MEMO

Subject: Correction of Record of Metro Planning Commission, January 8, 2026, Item #10, Case #2026Z-002TX-001

ATTACHMENT 1: East Bank Allowed Heights

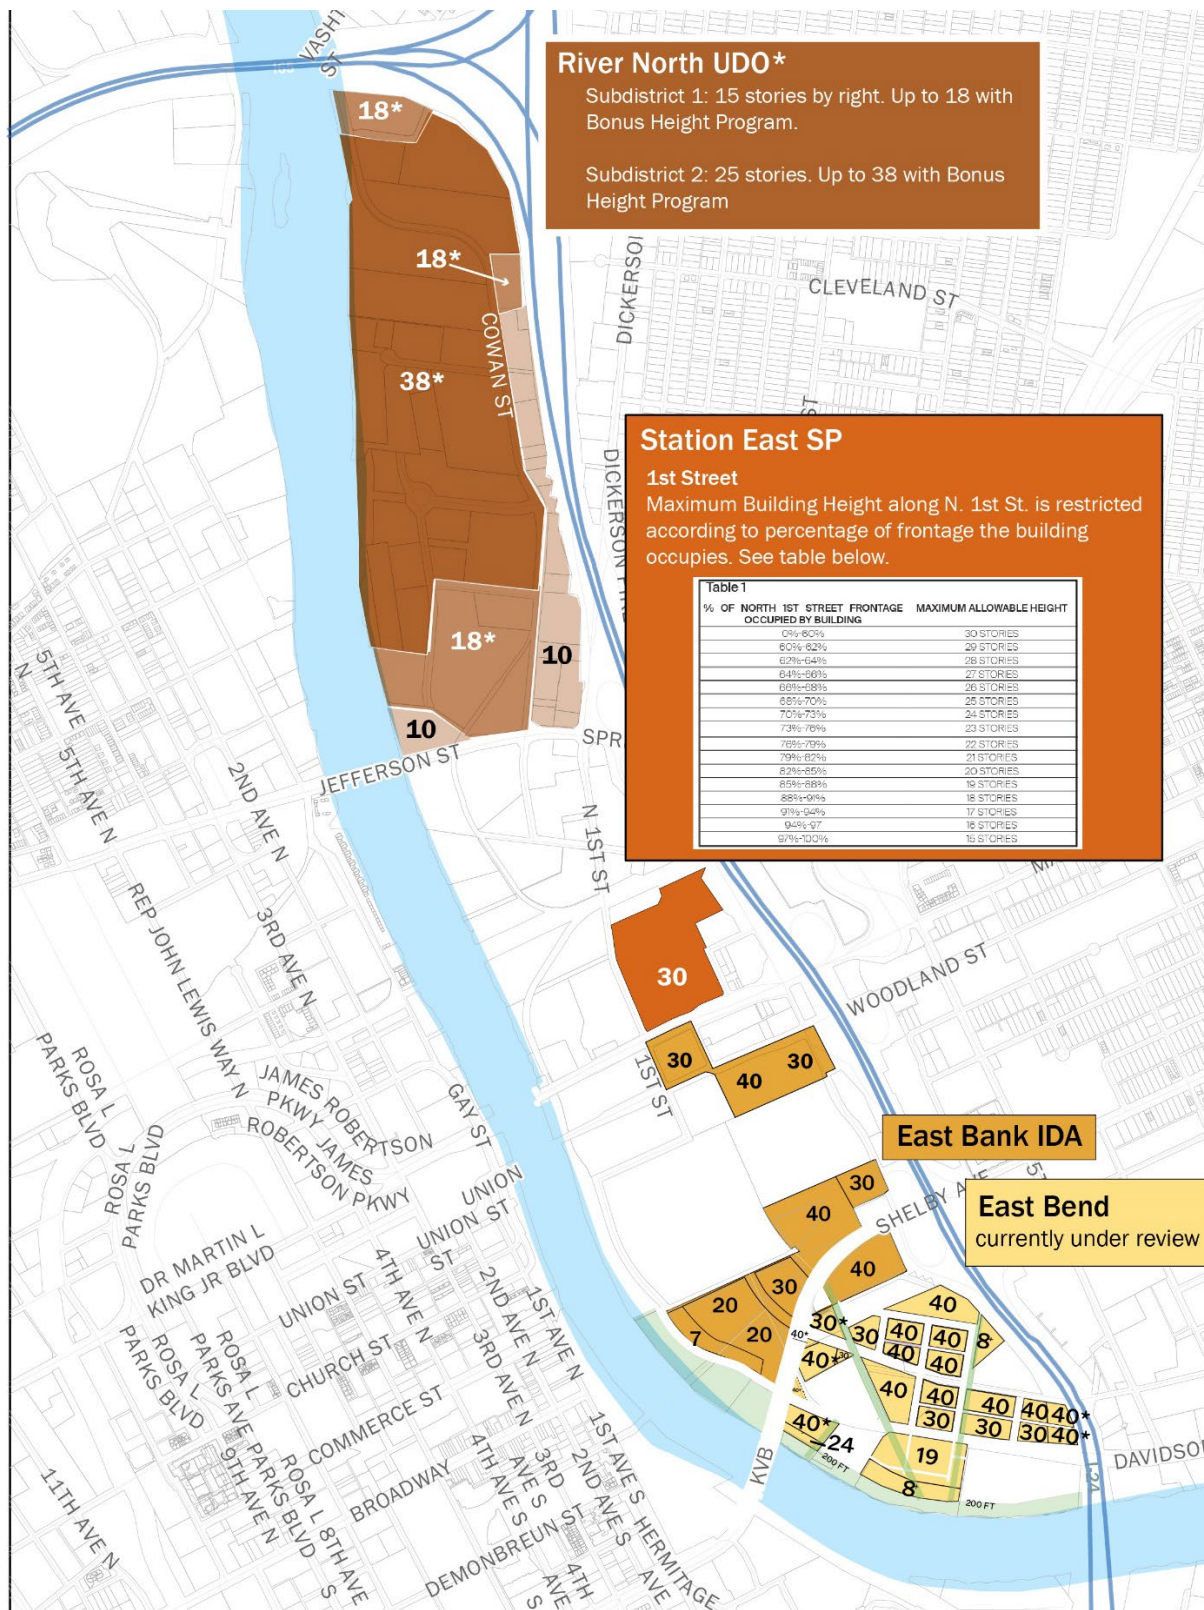
1. Commissioner Henley: How did the *Imagine East Bank*/IDA guidance and context (relationship to the river, stepping of heights, view corridors) inform the layout and treatment of the uniquely shaped/smaller parcels and pedestrian orientation? Is there some kind of guiding principle that was used? (≈0:02:00–0:05:22)

Refer to **Attachment 1** for a visual illustration of building heights

7. Commissioner Farr: Why are building heights up to 40 stories allowed so close to the river — shouldn't heights step down toward the river? How does this align with the other side of KVB/adjacent areas? (≈0:17:12–0:19:44, ≈0:21:14–0:23:24)

- The maximum heights in the Initial Development Area (IDA) vary by location within the East Bank subdistrict. Along Waterside Drive – the area closest to the river – height is restricted to 7 stories, and then steps up 20 stories, then 30 stories, with allowances for up to 40 stories in select locations nearer to the stadium, with a step down to 30 stories near the interstate.

- The maximum proposed heights in East Bend are 24 stories at Korean Veterans Boulevard and the river with 40 stories allowed deeper into that block, and 8 stories along the southeastern frontage of the river. On specific blocks, heights are limited to 19 stories and 30 stories. A maximum height of 40 stories is allowed in the majority of the subdistrict (13 of the 21 blocks in the subdistrict).

- Refer to **Attachment 1: East Bank Allowed Heights**
- Based on the Commission's questions, feedback, and review of the policy, the staff are continuing to evaluate the proposed heights.
- In the IDA, height is restricted to 7 stories along the riverfront with one step-up to 20 stories while on the west side of 1st Street. Additionally, in the IDA, all tower footprints are limited to a maximum size of 16,000 square feet.
- In the comparable area of the East Bend subdistrict – between Davidson Street and the river – heights vary from 24 stories and 40 stories near Korean Veterans Boulevard to 8 stories and 19 stories. As visible on the map, the area between Davidson Street and the river is closer to the river than the similar area in the IDA, which has a significantly greater depth of public open space along the river.

ATTACHMENT 2, PART 1: VIEWSHED ANALYSES

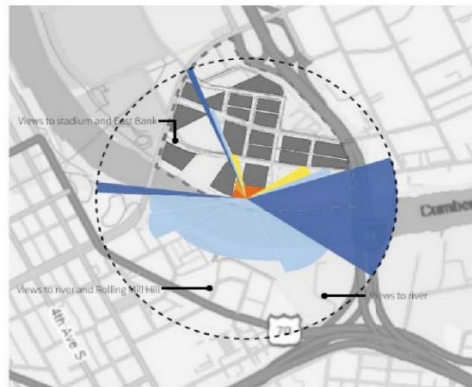
8. Commissioner Farr: How will tower placement rules (setbacks, floor plate limits, tower spacing) mitigate a "wall" effect and protect adjacent residential neighborhoods? (≈0:19:44–0:21:14)

- We are evaluating a shadow study provided by the property owners, as well as building footprints and heights, and will provide updated information at the next hearing.
- Refer to **Figure 1: Maximum Tower Floorplates** for a comparison between the IDA and East Bend.
